UNITED STATES PATENT AND TRADEMARK OFFICE

APPLICATION NO.	FILING DATE	FIRST NAMED INVENTOR	ATTORNEY DOCKET NO.	CONFIRMATION NO.
10/765,634	01/27/2004	Robert W. Helt	TIR 2748, 2837	2260

DETAILED ACTION

Figure 12a (Dushane)

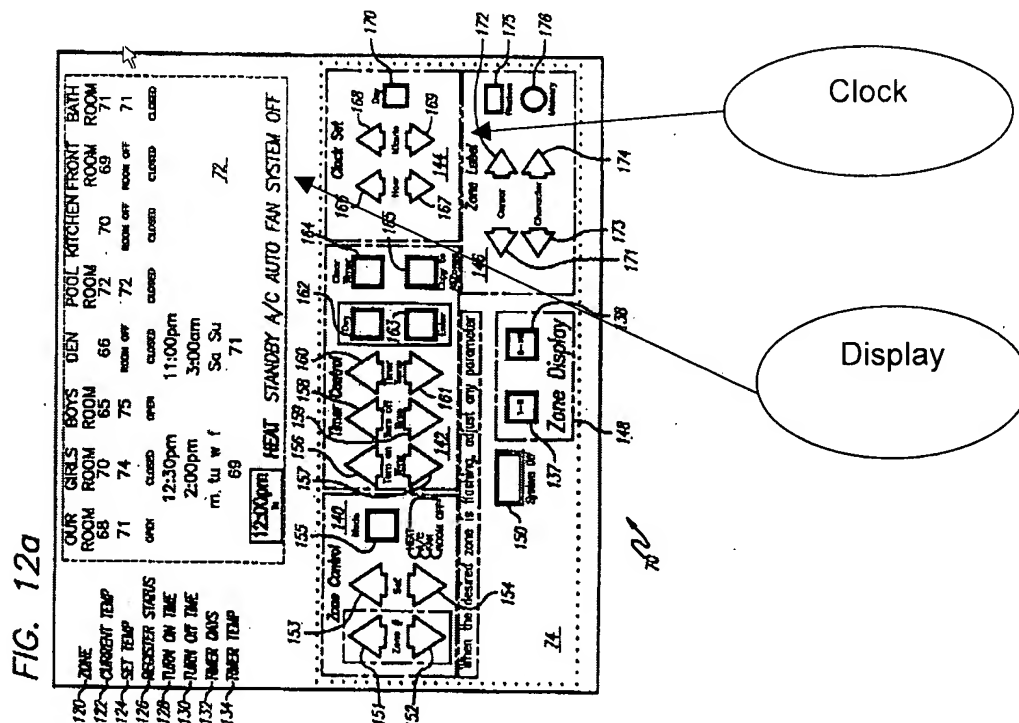
Regarding claims 3 and 5 Dushane discloses a thermostat with a master controller 70 corresponding to the claimed "control here" switch actuator (Figure 12a) that affects the control of the air conditioning unit to control the temperature in accordance with the temperature set point (column 11 lines 25-35). Though Dushane does not teach each thermostat has a "control here" switch controller it would have been obvious to modify Dushane such that each of the thermostats included a control here switch in order to notify users each thermostat is capable of changing the temperature in every building location in view of the teachings of Parker et al.

With regard to claim 6, Dushane further discloses a clock 144 and a visual display of time (Figure 12a). Dushane further teaches switch actuators capable of setting a time displayed by one of said thermostats to effect a change in the time displayed by each of the thermostats (column 9 lines 58-68). Parker et al. teach a

Regarding claim 7 Dushane discloses multiple thermostats with at least one including a time display, a Daylight Savings Time icon, and a Daylight Savings Time switch actuator capable of adjusting the time during Daylight Savings time periods (Figure 12a and column 11 lines 33-35).

With regard to claim 22, Dushane discloses thermostats including a clock, a time display and a clock setting switch actuator (Figure 12 a) and capable of setting the clock at one of the thermostats to display the time at all the thermostats.
